**Owens Valley PM₁₀ Planning Area
Demonstration of Attainment
State Implementation Plan**

Appendices C through K

**District Response to LADWP Comments on the
Draft 1997 Owens Valley PM₁₀ Planning Area SIP**

Figure 3.1-10

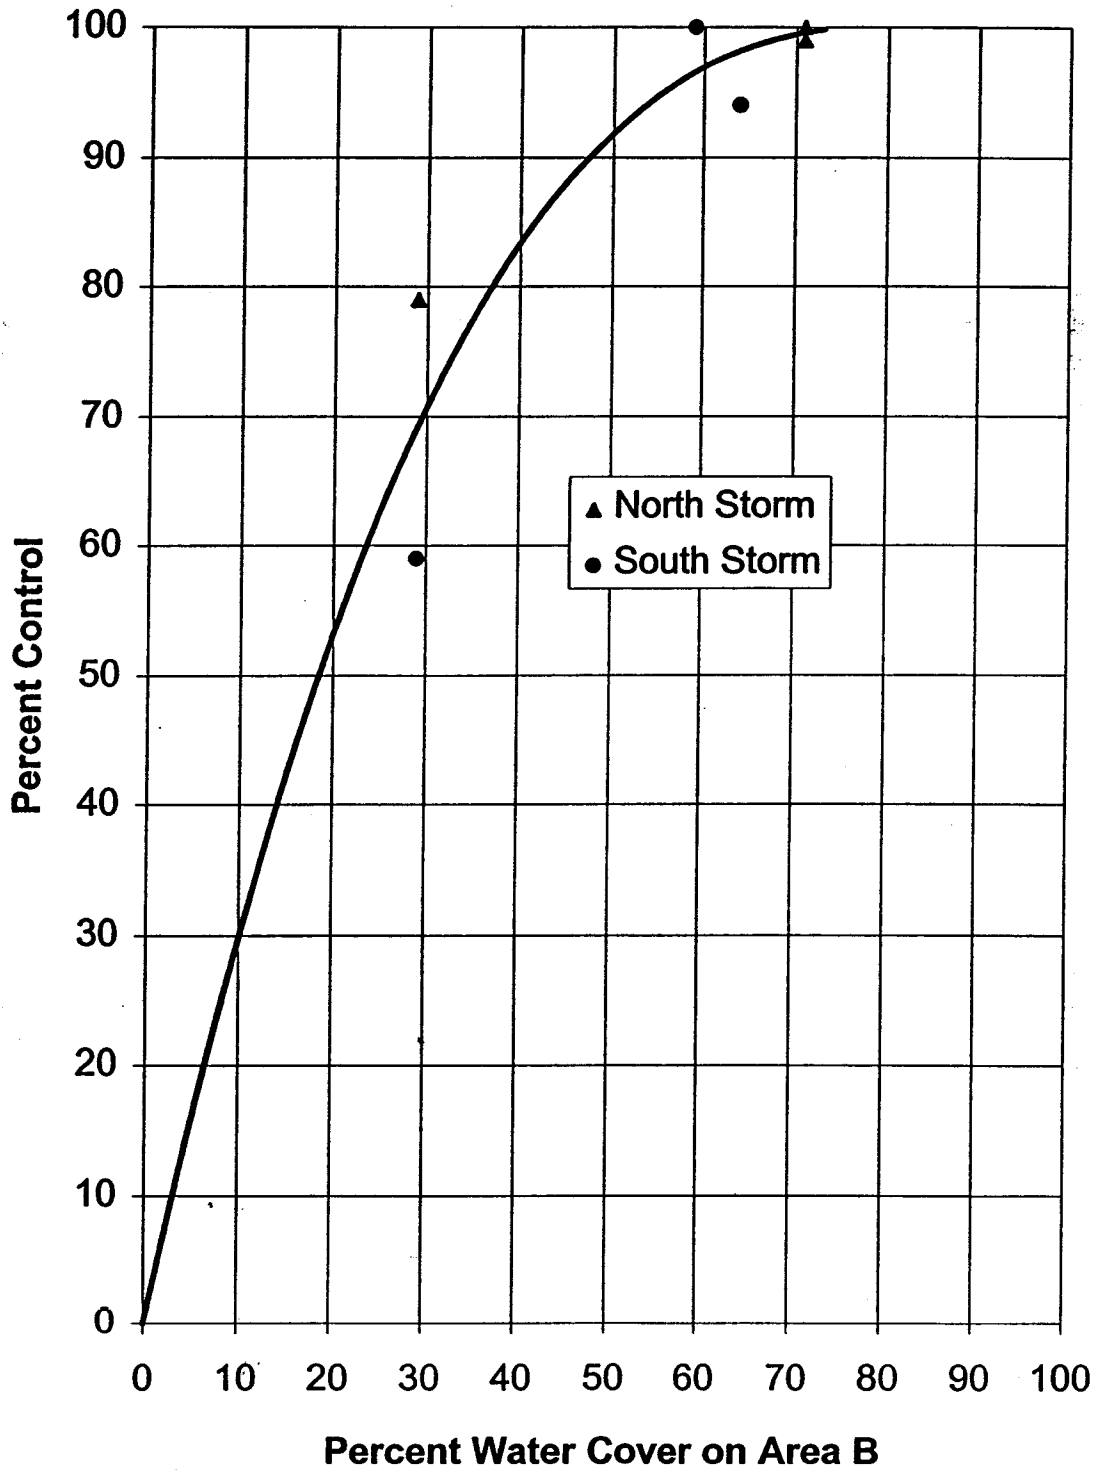
As shown by the sprinkler test at Owens Lake the soils will dry quickly, however, the saturated soil on the shallow flood project didn't dry and lose stability. The use of Sensits and sand transport samplers during the storm periods showed that the surface maintained the high level of control throughout the storms. Tests showed this level of control was related to the overall surface water cover provided during the storm (see DSIP Appendix D, Figure 3.1-10).

Figure 6. Number of exceedances per year (PM10 > 150 ug/m3) predicted by ISC using the Model Performance Evaluation (MPE) and Attainment Demonstration (AD) receptor networks, compared to historical observations (1987-1995) and TEOM measurements (1994-1995)

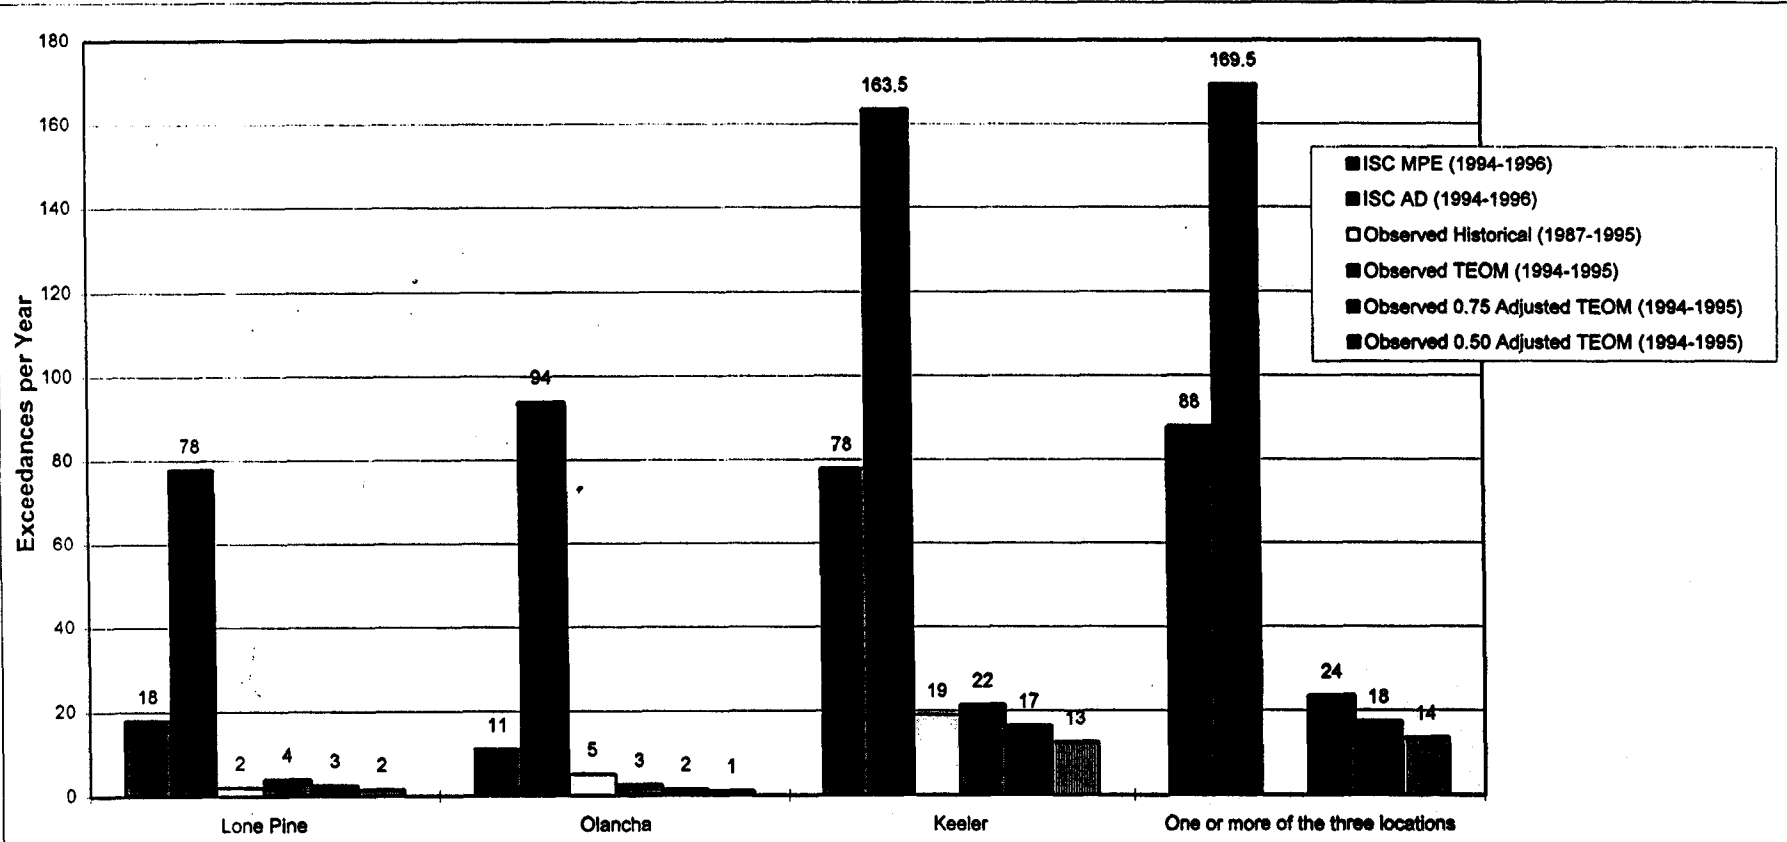
As reality checks of the draft OVPA SIP modeling, the following two predicted/observed comparisons were made: (1) the model estimated number of exceedance days per year was compared with the number of exceedance days per year which is historically observed in the Owens Valley and with what was observed concurrent with the modeling period; and (2) the modeling period database average predicted and observed long-term PM-10 concentrations were compared. Figure 6 compares the average number of exceedances per year that have been historically recorded at the three Owens Valley sites, and the average exceedances per year observed and predicted across the 1994-1995 modeling period. At Lone Pine, the observed average historical (1987-1995) number of exceedances is 2 per year. During the 1994-1995 modeling period there were 3 observed exceedances per year at Lone Pine (0.75TEOM). The OVPA SIP modeling estimates there would be 18 exceedance days per year at the Lone Pine site (MPE receptor network) and 78 exceedance days per year in the Lone Pine region (AD receptor network).

Figure 7. Database average PM10 concentrations (ug/m3) for 1994-1995 predicted by ISC using the Model Performance Evaluation (MPE) and Attainment Demonstration (AD) receptor networks, compared to observed data (TEOM, adjusted TEOM, and SSI)

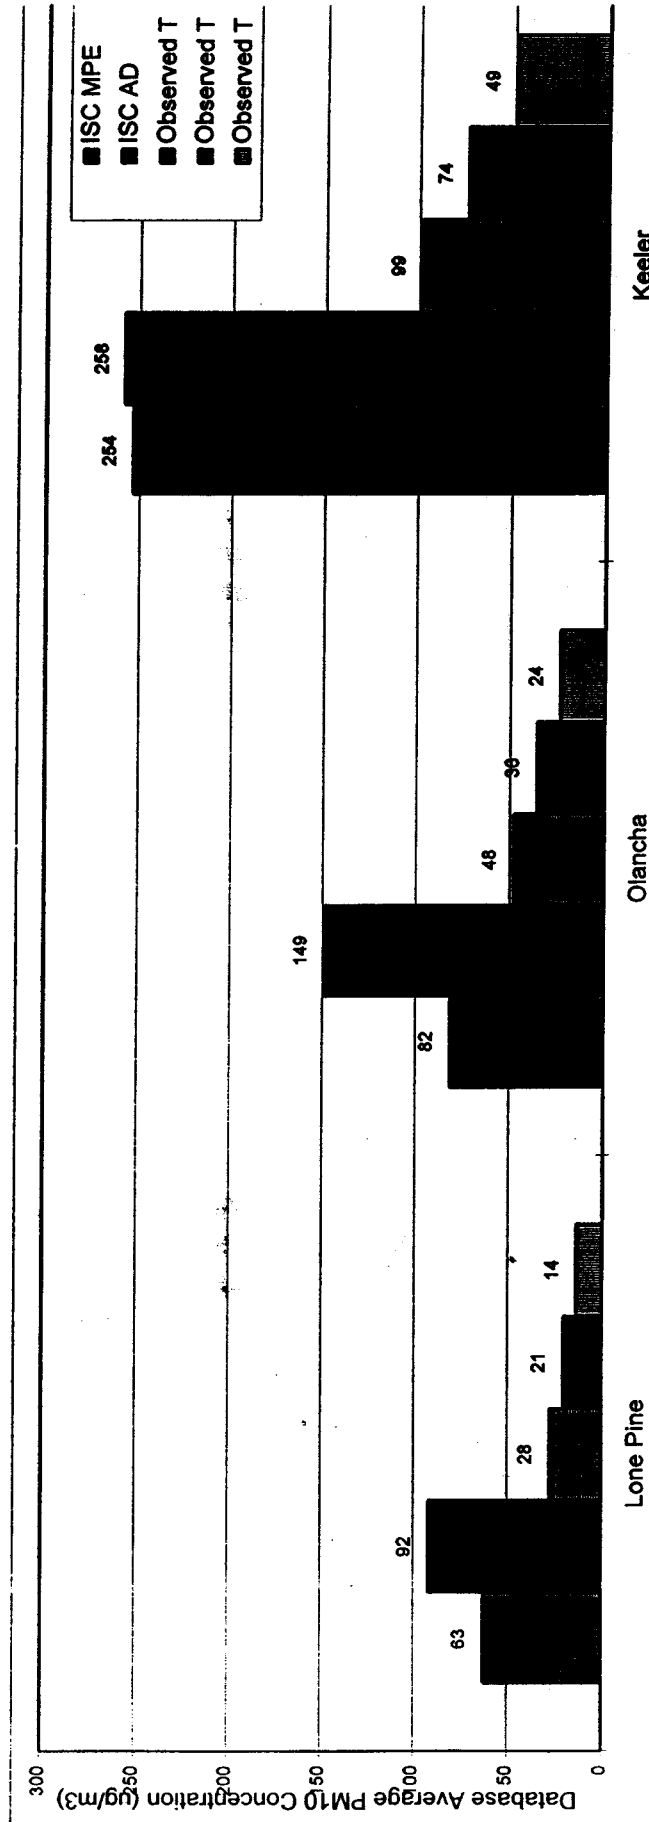
The overprediction bias of the draft OVPA SIP model is also seen in the comparison of the 1994-1995 modeling period average PM-10 predicted and observed concentrations shown in Figure 7. Note that because low wind speed periods were not included in the modeling period these database average concentrations should not be interpreted as annual averages. At Lone Pine, the OVPA model overestimates the observed long-term database average PM-10 concentrations by a factor of 3 to 4 depending on whether the predicted database average across the MPE or AD receptor network is used, respectively. At the Keeler site, the model estimated database average PM-10 concentration is 254 $\mu\text{g}/\text{m}^3$, over a factor of three higher than the corrected (0.75) TEOM (74 $\mu\text{g}/\text{m}^3$) value.
